Reference Cobra Model Numbers:
CXR700, CXR720, CXR725, CXR750, CXR755, CXR756

New FCC Identifier: **BBOCXR700** (original FCC identifier BBOLI5600)

Persuant to 47 CFR 2.933(b), Cobra Electronics Corporation requests modification of the FCC identifier, BBOLI5600 originally granted on 25 October, 2007 and associated with models LI5600, LI5590, LI5625, LI5650, and LI5675.

Figure 2

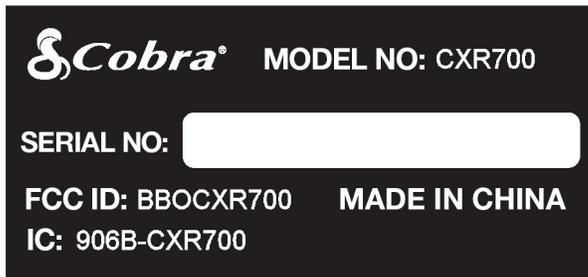
The new identification label to be used with these models is shown below as Figure 2. The label location is the subject of a separate request to FCC to locate the label in the battery compartment of the radio. A reference image from that proposal is included as Figure 3
